HDC

ADMINISTRATIVE APPROVALS

April 01, 2026

96 STATE ST.

① 04 - Roof
1/4" = 1'-0"

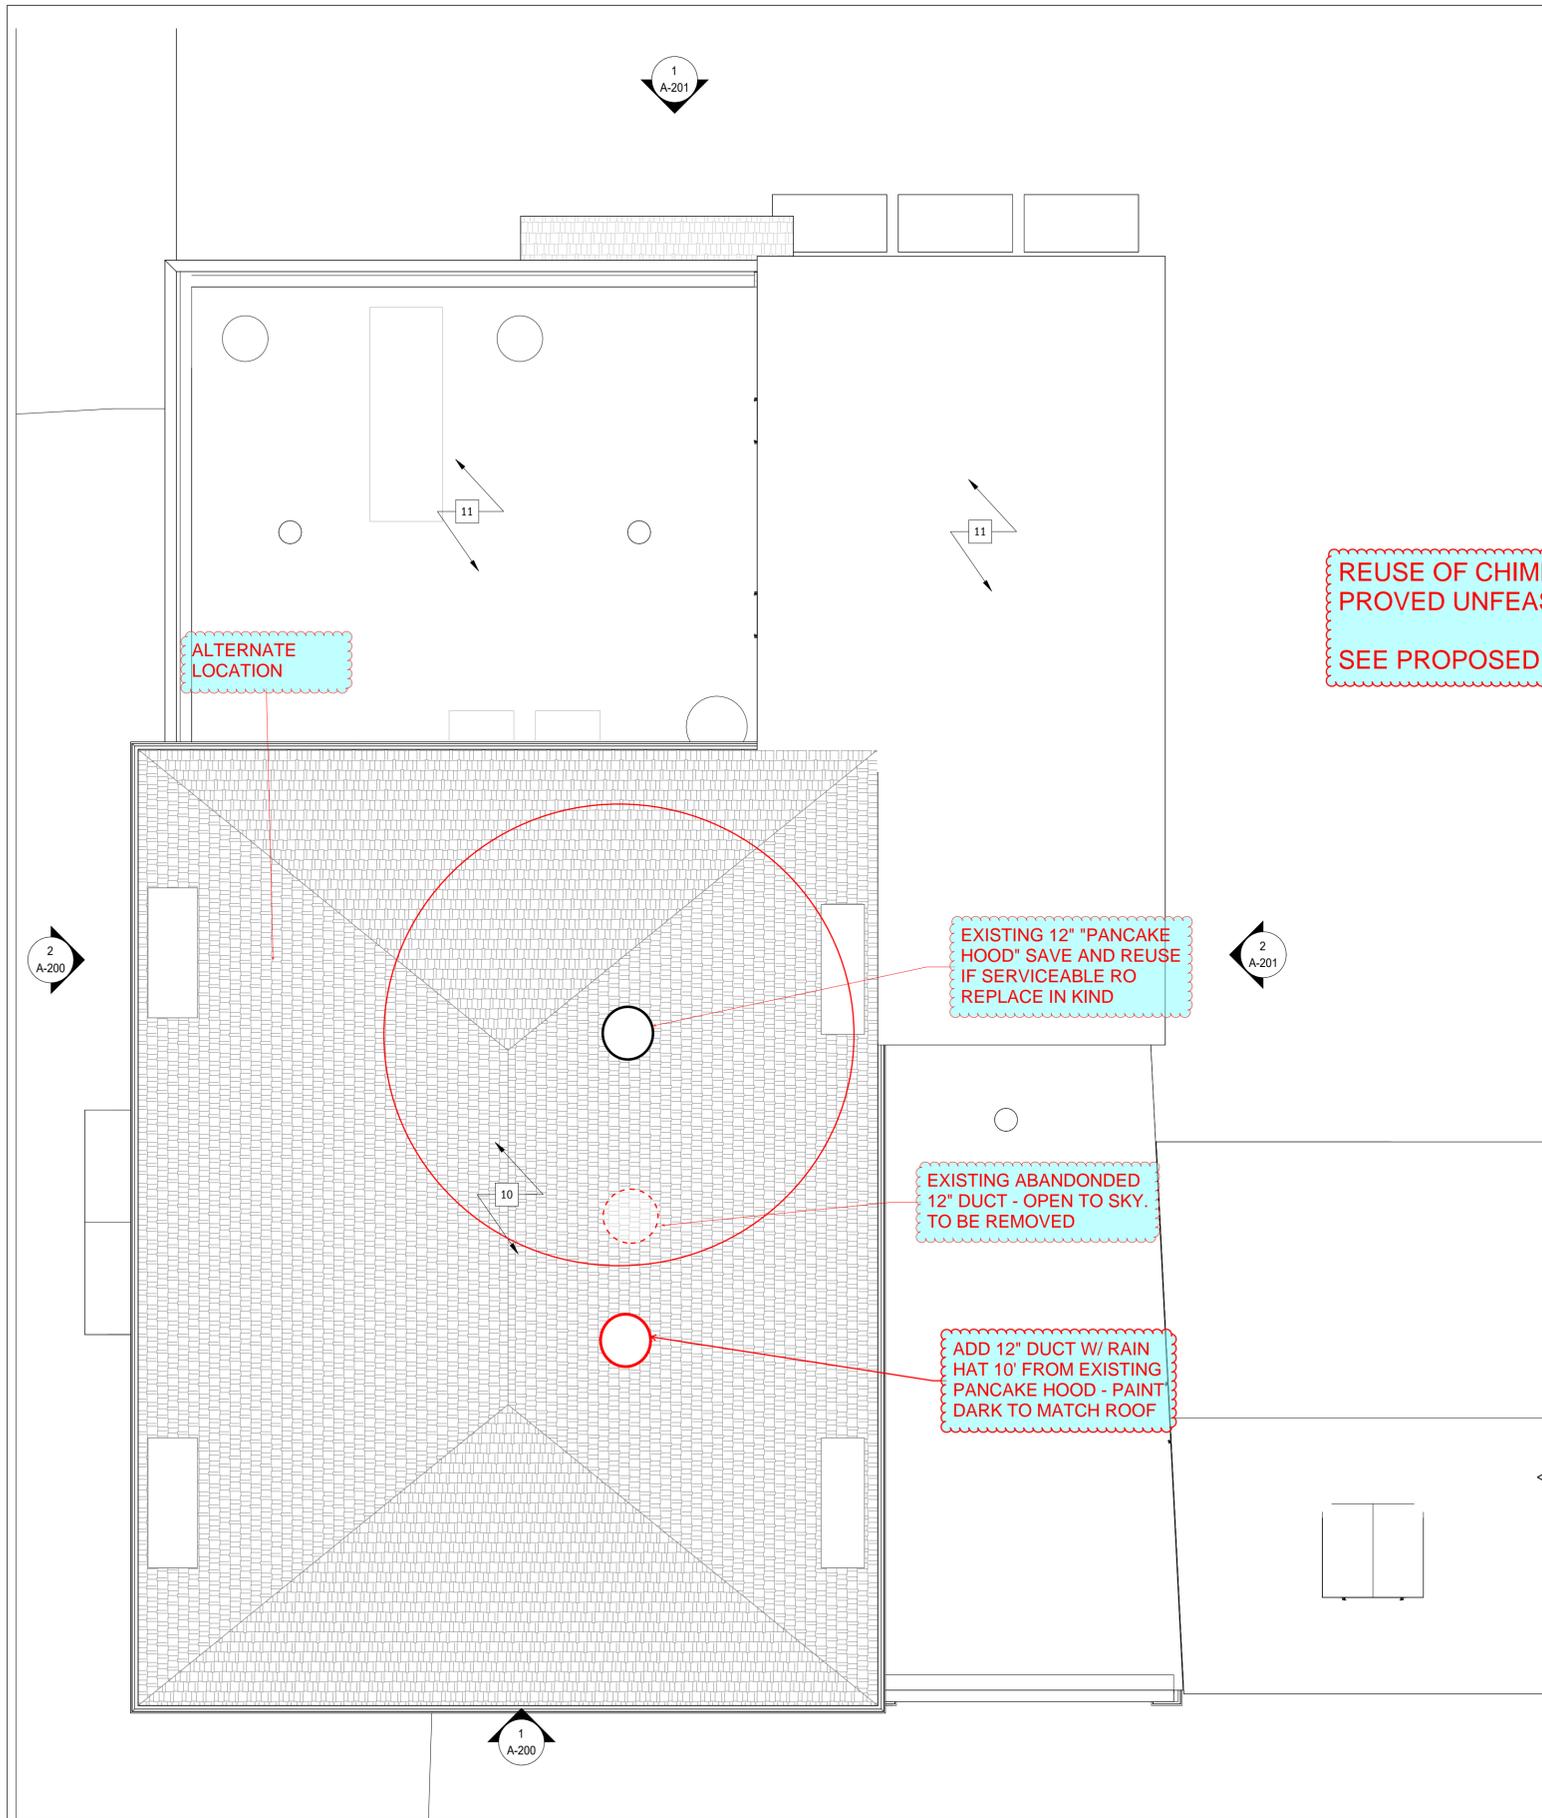
DWG H2.4 calls for 6" OA & EA runs through the existing chimneys.

Notes 1& 2 calls for chimney prep & coordinating with ARCH.

Notes on DWG H2.5 calls for capping the chimney.

- What are the OA vertical runs? 6" metal pipe?
- How do they penetrate the existing chimney?
- How do the runs get attached at the top of the chimney under the new cap? Do they stick up 2" and paint black so no visual impact? The Historical District would like to know prior to issuance of the MECH Permit.
- Please provide a detail for this chimney cap as well. Metal? Stone? Finish color, etc.

- APH and Martini were able to review the attic and roof penetration options for the ERV OA & EA on Thursday 2/26. It is our understanding that one 12" duct is needed for OA and one 12" duct is needed for EA and then both are branched over to the 3 attic ERVs.
- There exists a 12" attic roof duct into a pancake hood. This looks like it can be reused. Photos are below and plan drawing is attached.
- Near that pancake hood is an abandoned 12" duct that is open to the sky. Because this exists, we are only asking to R&R it and move it 10' (min) from the pancake head. New duct will be painted dark to match the new roof and have a low-profile rain cap on top.
- Attached are (4) photos and a marked up plan for your review.

Following our 2/24/2026 discussion, it was determined that chimney penetrations and utilizing the existing chimney flues for these (6) 6" pipes will not be feasible. We are looking for a route thru the building into the attic and penetrating the roof at (2) locations or utilize existing louvers for the current equipment that we could tie into.

This consists of a bank of (3) OA penetrations and another bank of (3) EA penetrations. See attached Snip of MECH DWG.

**REUSE OF CHIMNEYS FOR VENTING PROVED UNFEASIBLE.
SEE PROPOSED SOLUTION BELOW.**
